Agenda
Village of Arlington Heights
Design Commission
Community Room, 3rd Floor

Item: DC#18-092 - 1141 S. Arlington Heights Rd. / Commercial

STAFF DESIGN COMMISSION REPORT

Project Name: 1141 S. Arlington Heights Rd.
Project Address: 1141 S. Arlington Heights Rd.
Prepared By: Steve Hautzinger

A1

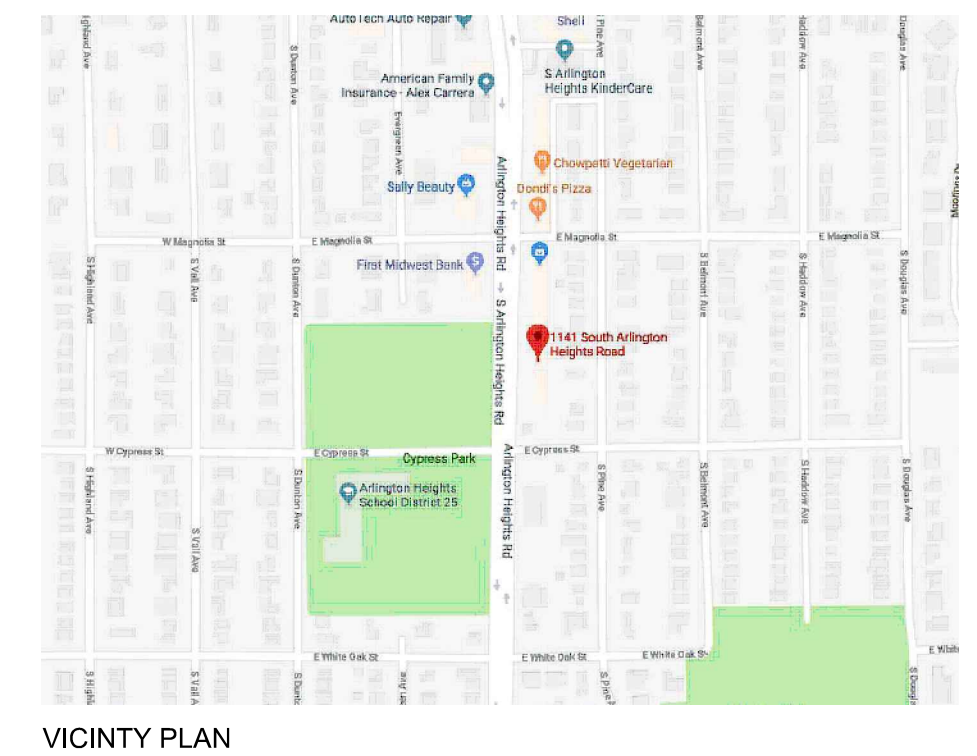
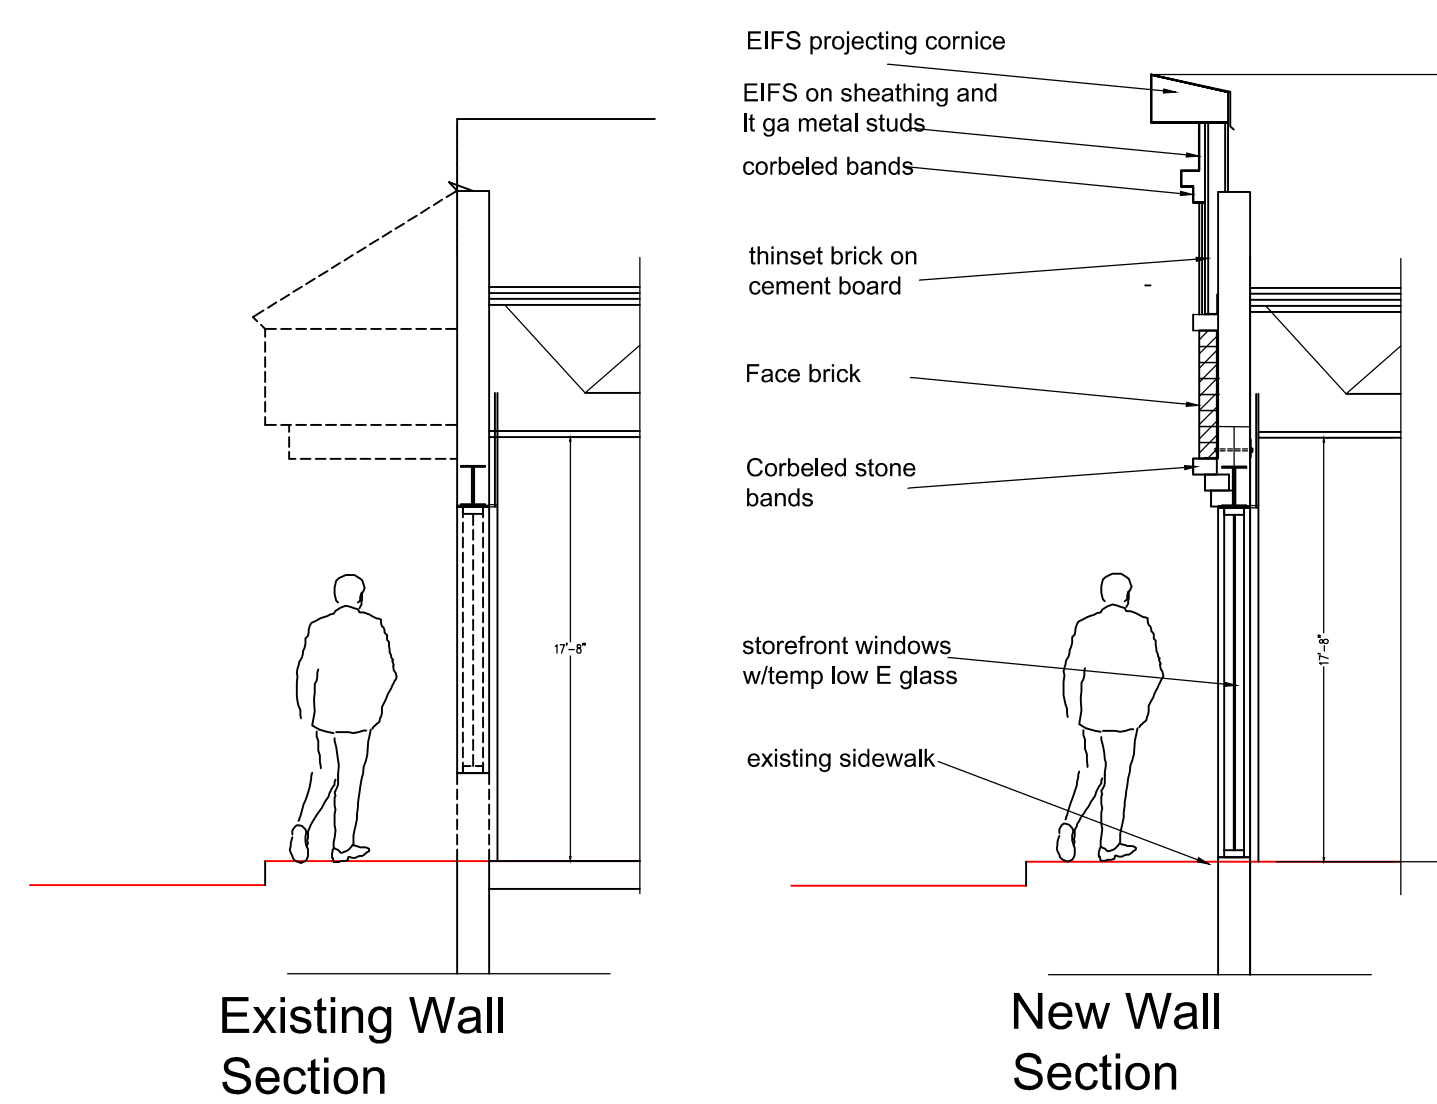
The drawings indicate a "continuous LED accent light strip", but the petitioner has clarified that this is an error and will not be part of the design.

2. Evaluate if the proposed design is too similar to the petitioner's recently completed project at 1005-1015 S. Arlington Heights Road.
3. Acknowledgment that the design does not include a continuous LED accent light strip.

Similar Facade Renovation Recently Completed by Same Petitioner

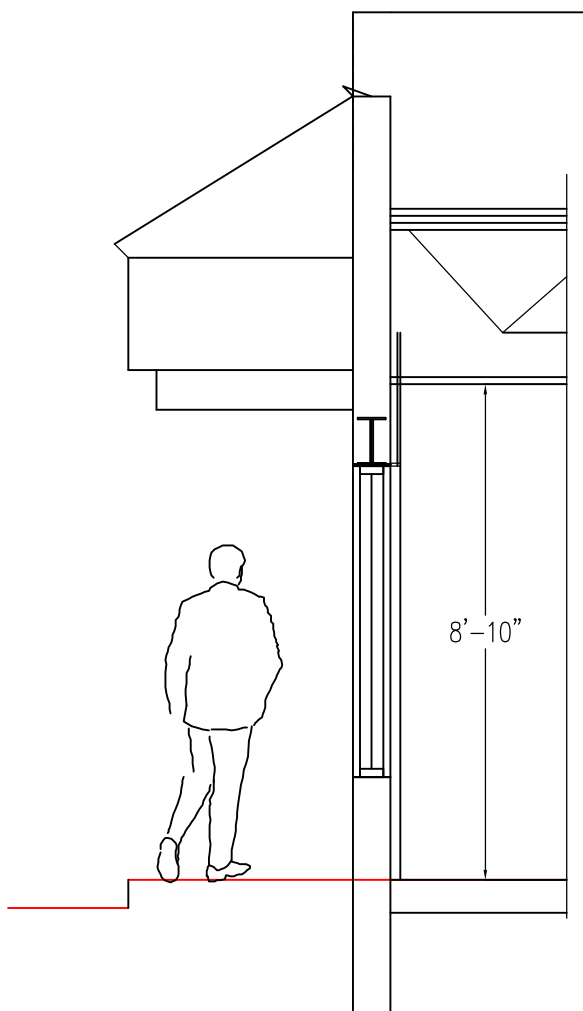
The existing building is generally in good condition, but the standing seam faux copper mansard canopy has a dated and unexciting appearance. The proposed design and materials will provide a brighter and fresher appearance that will enhance the properties' image. The petitioner has indicated his preference for keeping the design clean, simple, and modern, but the Design Commission should evaluate if the design could benefit from further design development, such as varying the height and profile of the cornice or incorporating decorative awnings or canopies above the storefronts or entry doors. Furthermore, the Design Commission should evaluate if the proposed design is too similar to the petitioner's recently completed project at 1005-1015 S. Arlington Heights Road.
